Subject: Implementing ultra-precision flat carrier tape and updating pressure seal tape

PCN #: PCN-01371

Title: Tape and reel carrier tape change

PCN Details

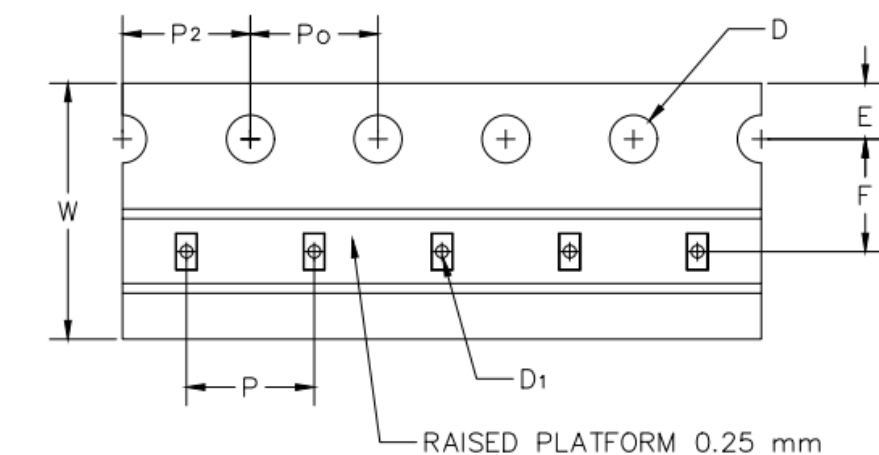
The carrier tape is being converted from raised channel to an ultra-precision flat pocket with tighter tolerances.

In addition, the cover tape will change From Pressure Seal (PSA) 3M 2668 to Heat Seal (HAA) Advantek HUC0054-300

Dimensions and shape for carrier tape changes are shown below.

DIMENSION	SPEC.(mm)
W	8.00 +0.30/-0.10
P	2.00 ± 0.05
E	1.75 ± 0.10
F	3.50 ± 0.05
D	1.50 ± 0.10
Po	4.00 ± 0.10
P2	4.00 ± 0.10
Ao	0.65 ± 0.05
Bo	1.15 ± 0.05
Ko	0.20 ± 0.05
D1	0.40 ± 0.05
t	0.25 ± 0.02
